3 July 2025

**RE:** Request to Amend Regional Interest Development Approval RPI25/002 Anglo American – Planet Downs Project (Exploration Drilling)

Figure 1 RIDA Attachment 1 – Approved Plan

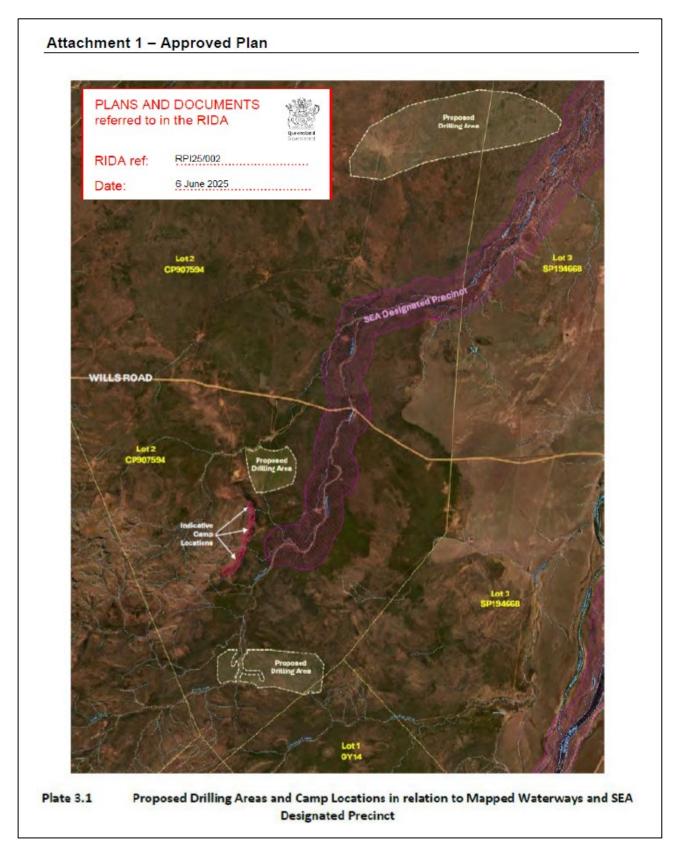
As described in the RIDA Supporting Report and as shown on Attachment 1 – Approved Plan of the RIDA (refer Figure 1), there are three Proposed Drilling Areas planned for exploration drilling. The total area of disturbance across these Proposed Drilling Areas is up to 1.0 ha for exploration drilling, and up to 2.4 ha for the construction of temporary access tracks.

Figure 2 Proposed Amendment of Drilling Areas shown in relation to Mapped Waterways and SEA Designated Precinct

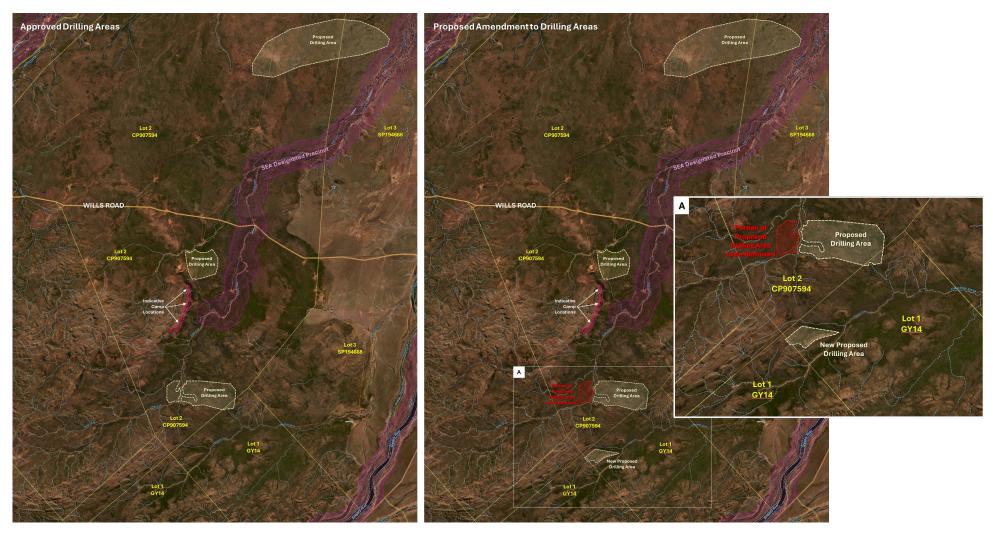
Since the submission of the RIDA applications in February, Anglo has undertaken additional desktop assessments and analysis, and determined that a portion of the southern Proposed Drilling Area may not be as prospective as originally thought, and Anglo now wish to relocate this portion to an area further to the south (refer Figure 2).

The New Proposed Drilling Area covers an area of approximately 146.1 ha, which is of a comparable size to the original drilling area that is proposed to be relocated (146.2 ha). The New Proposed Drilling Area does not intersect with the SEA Designated Precinct.

(Image on the left showing the currently approved drilling areas in RPI25/002 RIDA dated 6 June 2025, with images on the right showing proposed amended drilling area)

Figure 3 Proposed Amendment showing Relocated Drilling Area

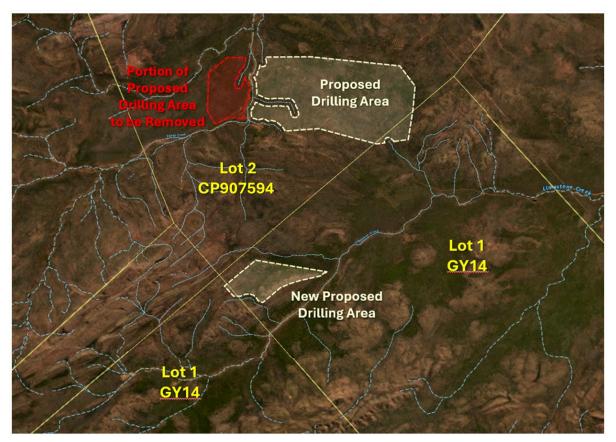
The land relevant to the proposed amendment is shown on Figure 3 and described in Table 1.

The New Proposed Drilling Area is located 100 m from mapped drainage features (refer **Figure 3**), and does not contain any mapped wetlands or springs. No creek crossings are required to be constructed for activities within the New Proposed Drilling Area.

Figure 4 Amended Proposed Drilling Areas in relation to Mapped Waterways and SEA Designated Precinct

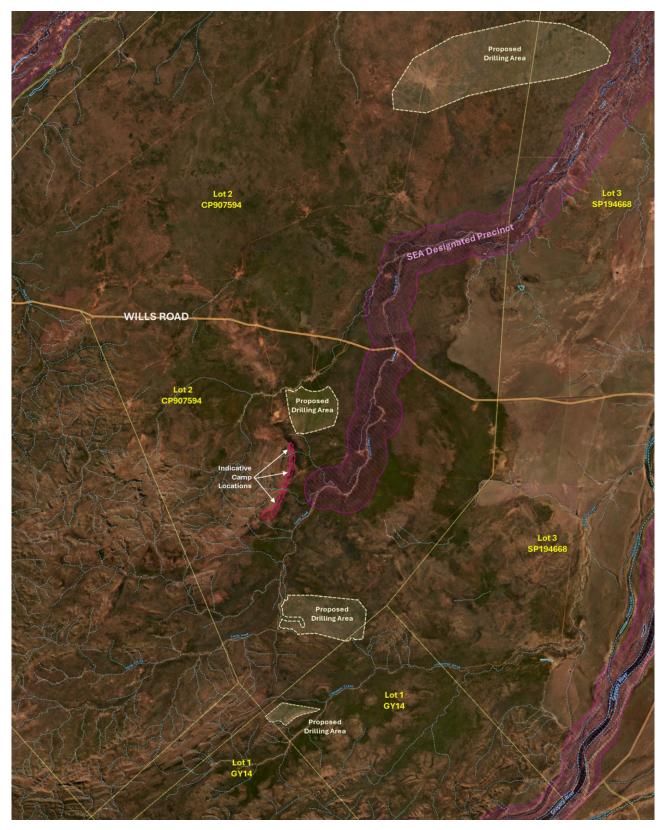
- Attachment 1 Approved Plan
- Condition 1(c) (which references the figure provided in the RIDA application document).

Suggested amended wording for condition 1(c) is provided as red text in **Table 2**, and a revised figure to be included in Attachment 1 – Approved Plan is provided at **Figure 4**.

No.	Current RIDA Conditions	Suggested Revised Conditions
1.	Carry out the approved resource activities in the Gulf Rivers SEA generally in accordance with:	Carry out the approved resource activities in the Gulf Rivers SEA generally in accordance with:
	<ul><li>(a) the resource activities identified in Table 1: Approved resource activities;</li></ul>	<ul><li>(a) the resource activities identified in Table 1: Approved resource activities;</li></ul>

(b) the resource activities as described in Table 2: Description summary of the proposed resource activities in the Gulf Rivers SEA; and	<ul> <li>(b) the resource activities as described in Table 2:</li> <li>Description summary of the proposed resource activities in the Gulf Rivers SEA; and</li> </ul>
	(c)-Plate 3.1 Proposed Drilling Areas and Camp Locations in relation to Mapped Waterways and SEA Designated Precinct (Attachment 1) as provided in the submitted RPI Act Development Application Supporting Information Report, Version 02, prepared by Umwelt (Australia) Pty Ltd, dated 13 February 2025.	(c) Figure 4 Amended Proposed Drilling Areas in relation to Mapped Waterways and SEA Designated Precinct (Attachment 1) as provided in the Request to Amend Regional Interest Development Approval - RPI25/002 Anglo American - Planet Downs Project (Exploration Drilling), letter from Umwelt to DSDIP, dated 3 July 2025.
